**Appeal Under the Town and Country
Planning Act 1990 (as amended) against
Decision of Refusal by Wrexham County
Borough Council**

**Land East of Bottom Road, Summerhill,
Wrexham**

PROOF OF EVIDENCE - HIGHWAYS

DRAWING No 1606405 REV E

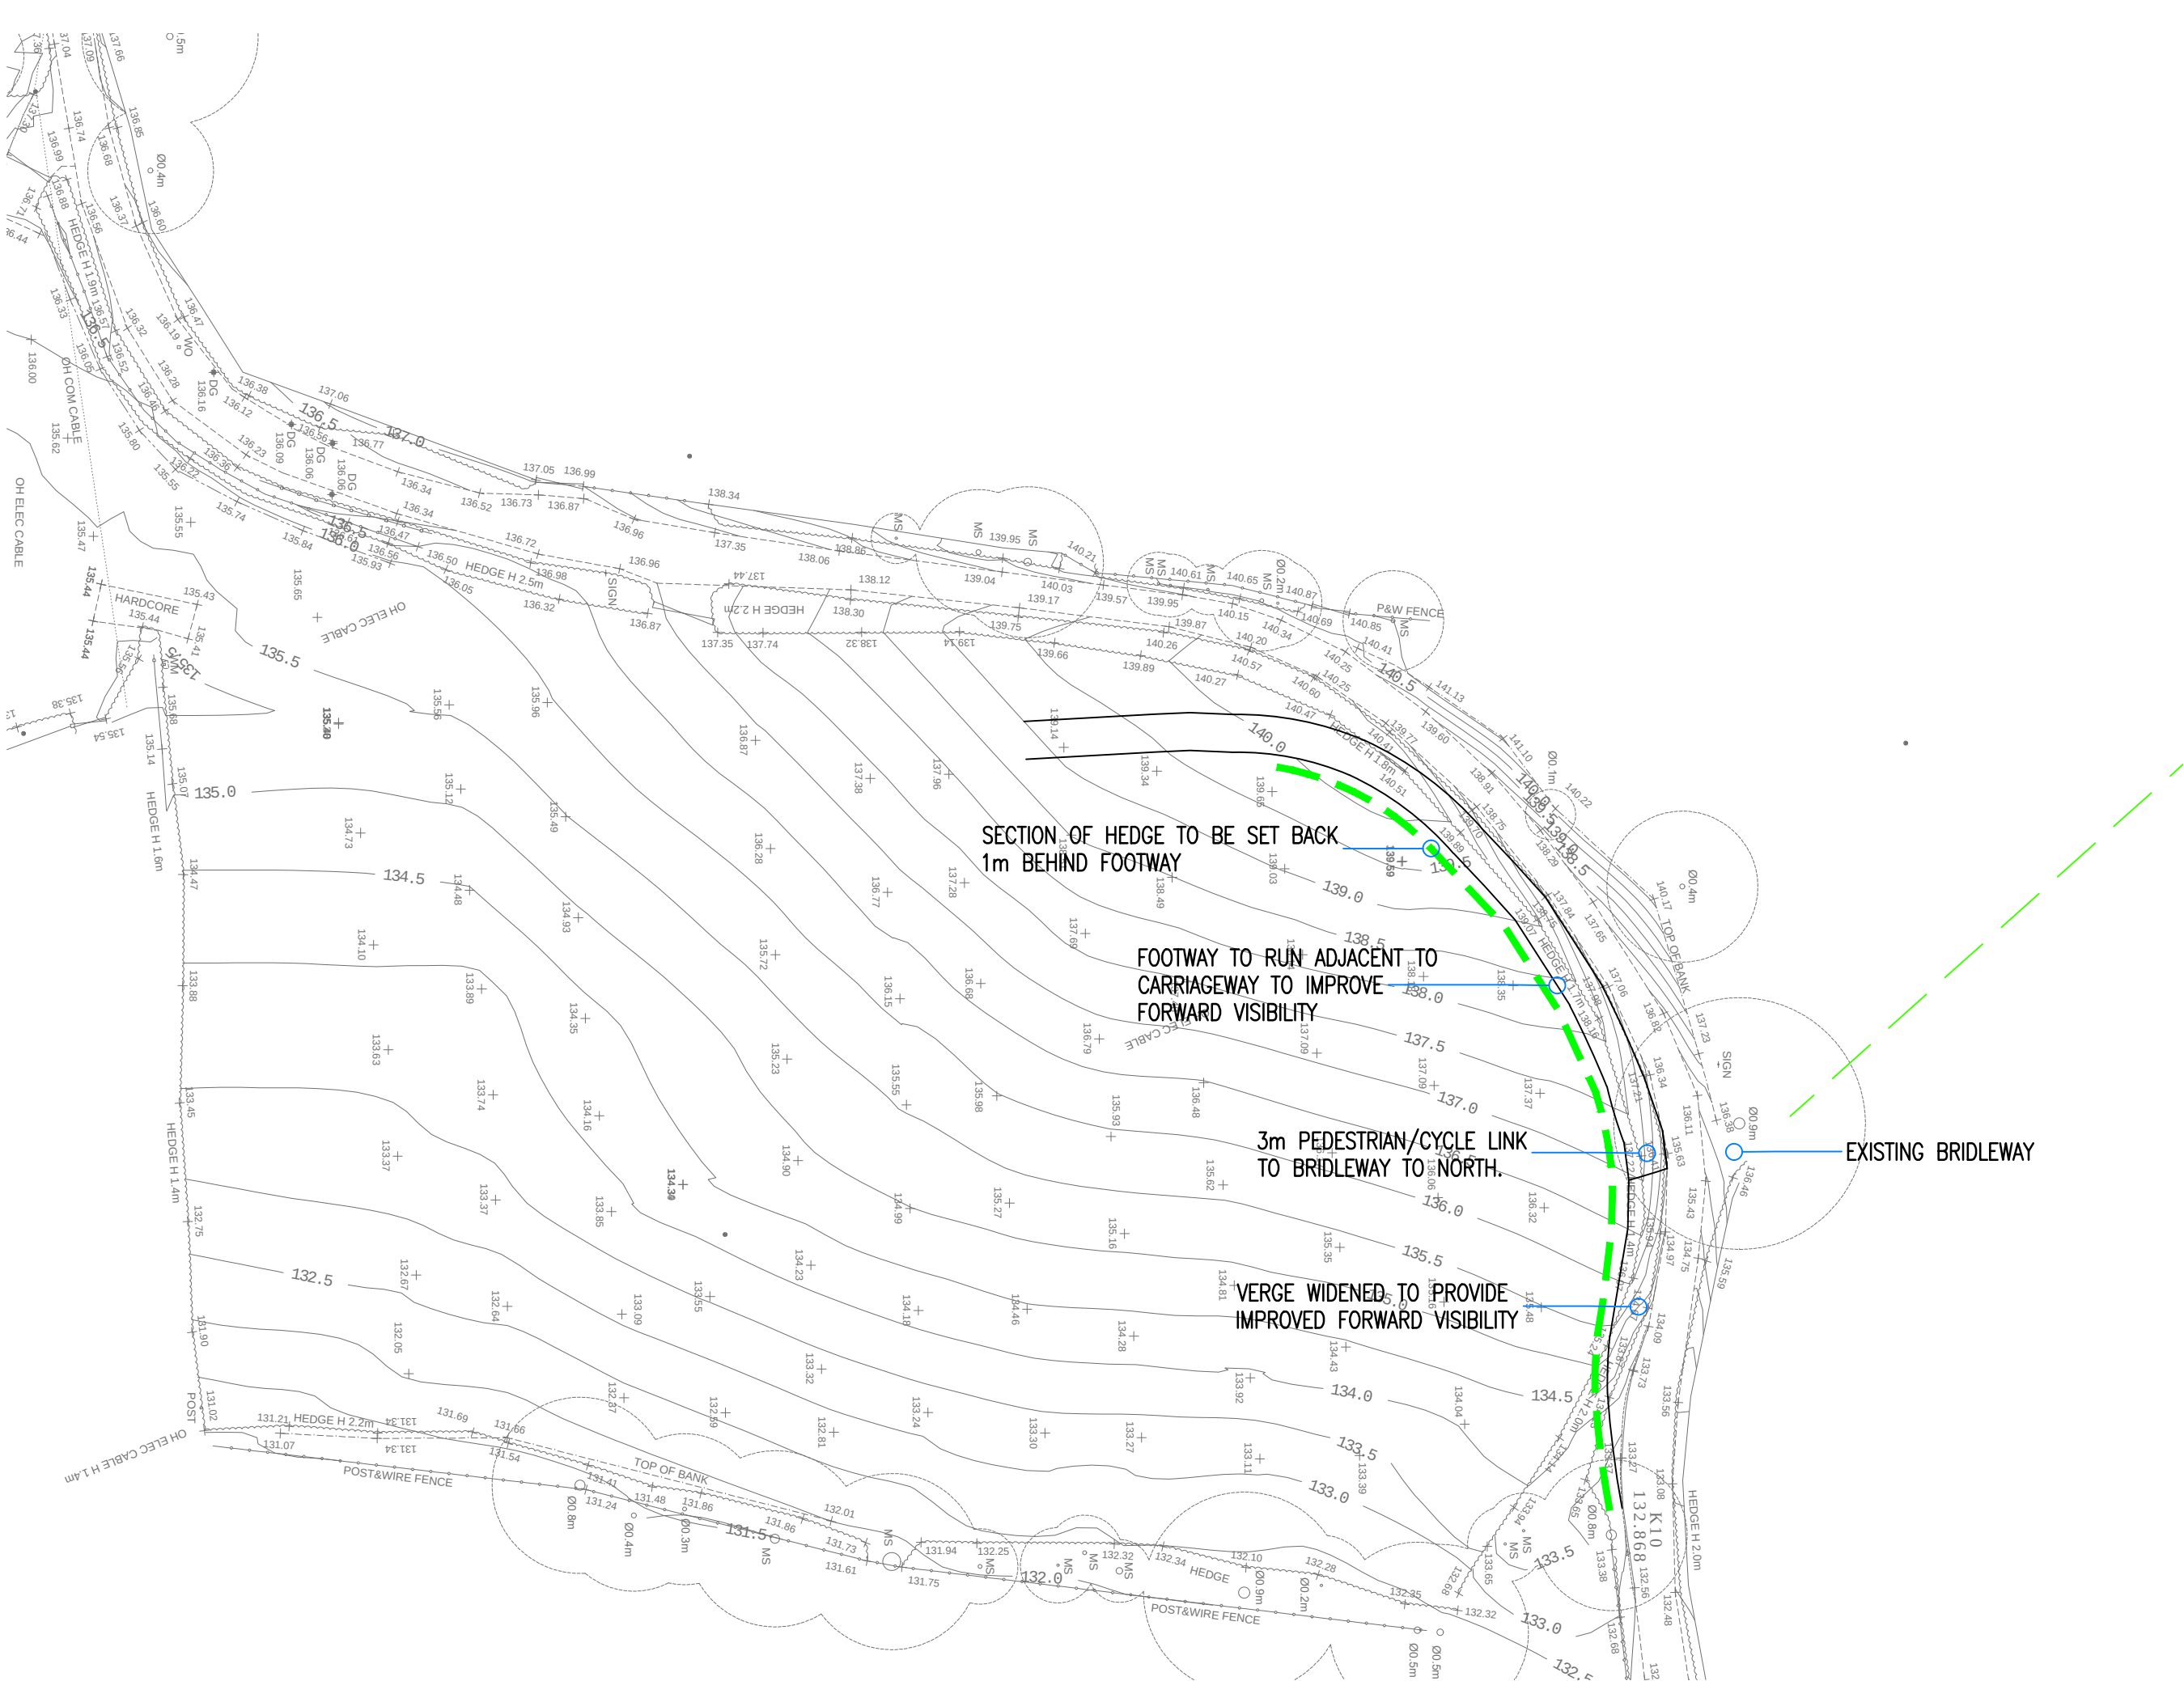
- ✦ Creation of priority system on Bottom Lane to south of the proposed access – see drawing 1606402 Rev F
 - ✦ Provision of improved junction of public right of way at northern extent of site on to the un named section of road between Bottom Lane and the A541 – see drawing 1606405 Rev E

- 3.3.8. The third measure will retain the improved junction of the public right of way at northern extent of the Appeal Site on to the un named section of road between Bottom lane and the A541 – see drawing 1604605 Rev E. This provides significant benefits to users of the existing public rights of way with improved visibility be afforded to users and other traffic.
